## **Stained Glass Studio**

September 9, 2019

Superintendent - Edwards -Knox Central School District

Dear Erin: It was a pleasure to meet with you and your associates at the school. It is nice to know that your pride in the window is so strong. I offer this advice for the recent visible issues.

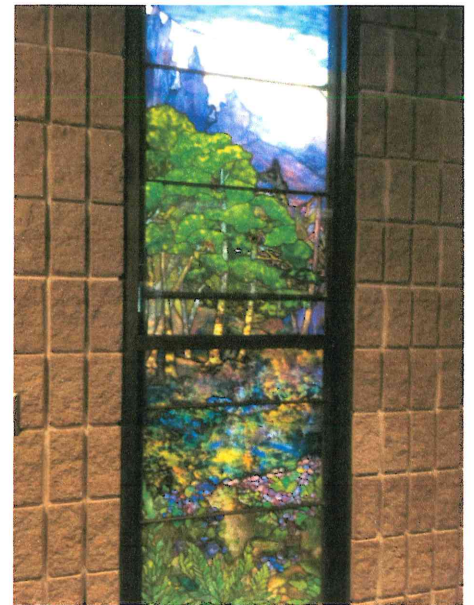
Replace sagging putty glazing and repaint rebar

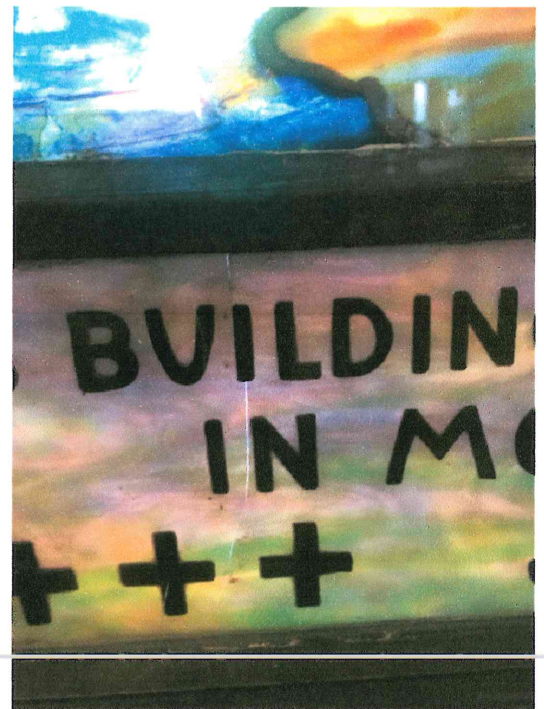
Remove , repair ,clean  
and re-set glass

Clean and fill small daylight areas
